UNIVERSITY OF CALIFORNIA LICK OBSERVATORY		4 CHANNEL TEMPERATURE SENSOR BOARD	
DES'N BY: B. Alcott	ORIGIN DATE: 03-17-04	DWG. NO.	NUM. 2 OF 2
Last SN	MODIFY DATE: 04-26-07	EL-1356	REV. B
PRINT TIME: 10:59:46	PRINT DATE: Thu Apr 26, 2007		
PATH: GENERAL\EL-1365\4ch_temp_sensor		4ch_temp_sensor_B.sch

MODIFY CIRCUIT 3

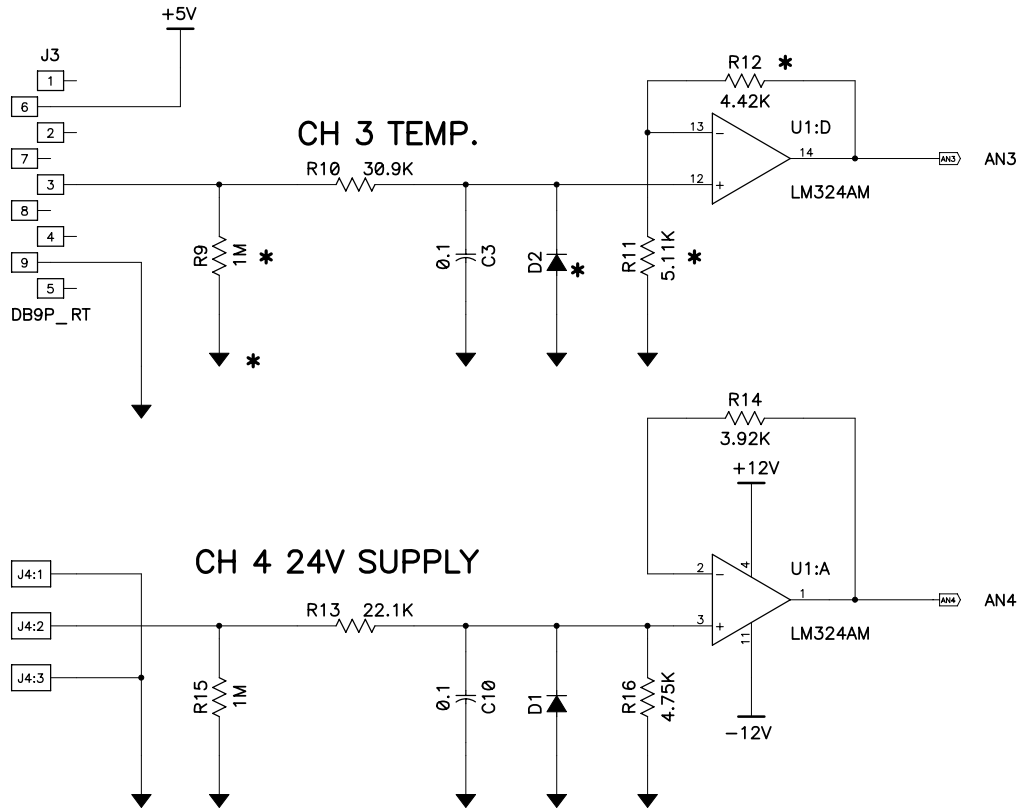
- * Modifications for adding 36V servo supply:
1. Remove R9, R10, R11, and R12
 2. Isolate -15V pad at bottom of R9 by cutting trace between it and pad of R5.
 3. Install the four new resistors.
 4. Add a wire from the isolated pad of R9 to the GND plane.
 5. Add a 1N4001 diode with the cathode soldered to the input side of R9 and the anode soldered to the GND plane.
 6. Run a pair of wires from the new power supply to J3 of board. Connect +36V to pin 3 and GND to pin 9 of the connector.

04-14-04 CHANGED BOARD NAME TO 4 CHANNEL FROM 3 CHANNEL
 04-26-07 MODIFIED THE CHANNEL 3 CIRCUIT FOR MONITORING A 36V POWER SUPPLY INPUT. THE SIGNAL SHOULD BE WIRED TO J3 - +36V ON J3-3 AND GND TP J3-9.
